SUPPLEMENT TO THE
SAFETY EVALUATION REPORT
FOR
THE PWR COOLANT CHEMISTRY LOOP (PCCL)
MITNRL-020

to be
installed and operated in the
MITR

April 19, 1988

For Review by the
MITR Safeguards Committee
and by its
PCCL Subcommittee

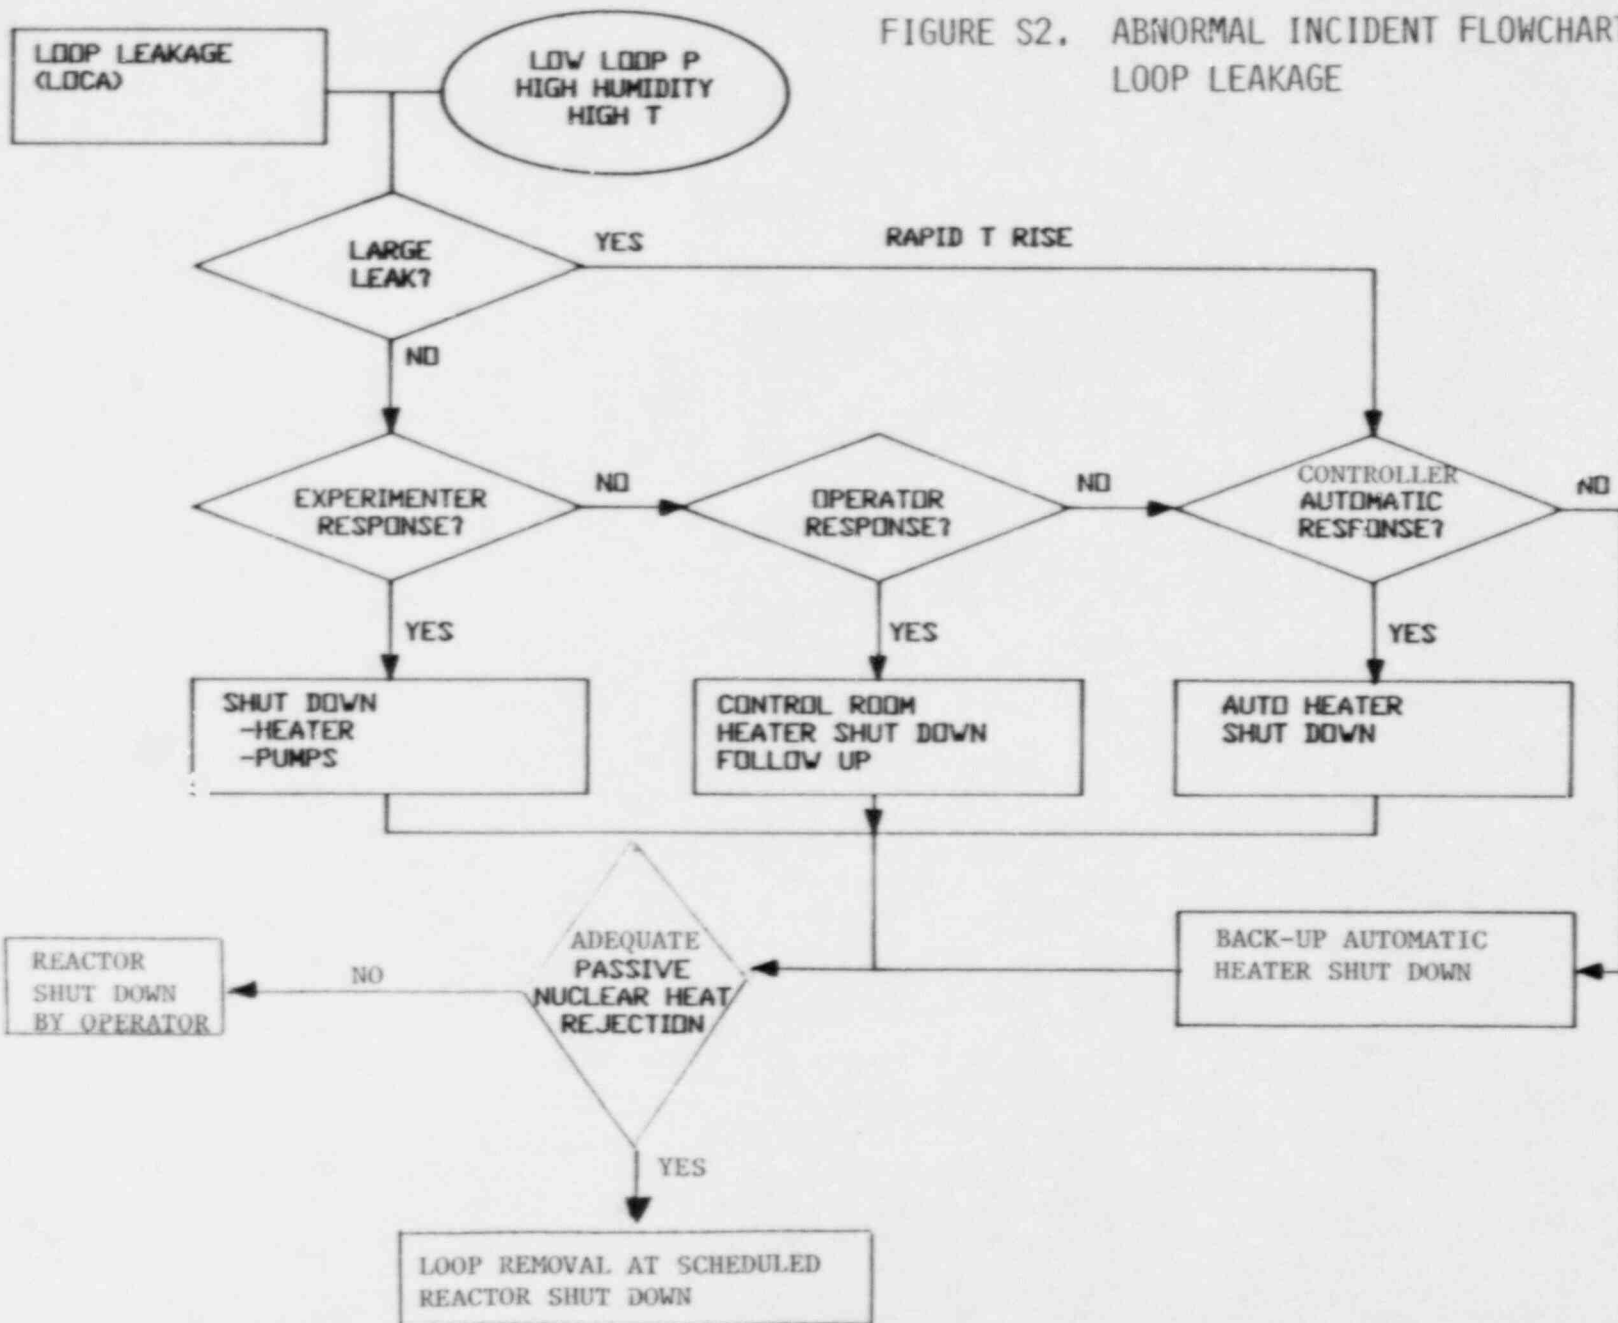
The basic philosophy of loop control and accident response remains the same as that outlined in the SER. It has been shown that all serious loop accidents eventually lead to overheating of the lead bath, and that consequences to the reactor are avoided if the electric heater is shut off. Therefore, the only automatic shut-down systems provided are triggered by high temperature in the lead bath. In order to clarify the sequence of events arising from potential accident scenarios, a sample

flowchart (Fig. S2) which details the predicted pathway arising from a loop leakage accident is provided to replace Table 3.1 of the SER. Alarms at the experiment panel and in the control room are provided for abnormal conditions of temperature, loop pressure, thimble humidity and charging tank level. See Appendix 1 for a description of the alarm circuits.
